First Named Inventor:	Ammar Al-Ali	Nonprovisional Application Number (if known):	Unassigned
Title of Invention:	ADVANCED PULSE OXIMETRY SENSOR

RESPONSE TO NON-FINAL OFFICE ACTION DATED OCTOBER 21, 2019

FIG. 7A

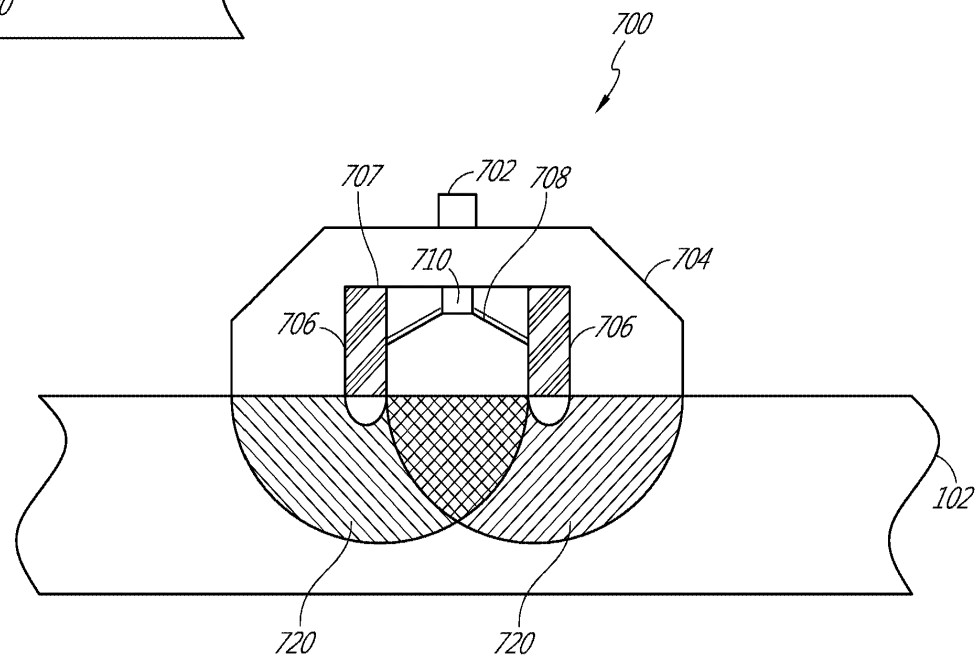
Please replace Figure 7A with the enclosed *Replacement Sheet*.
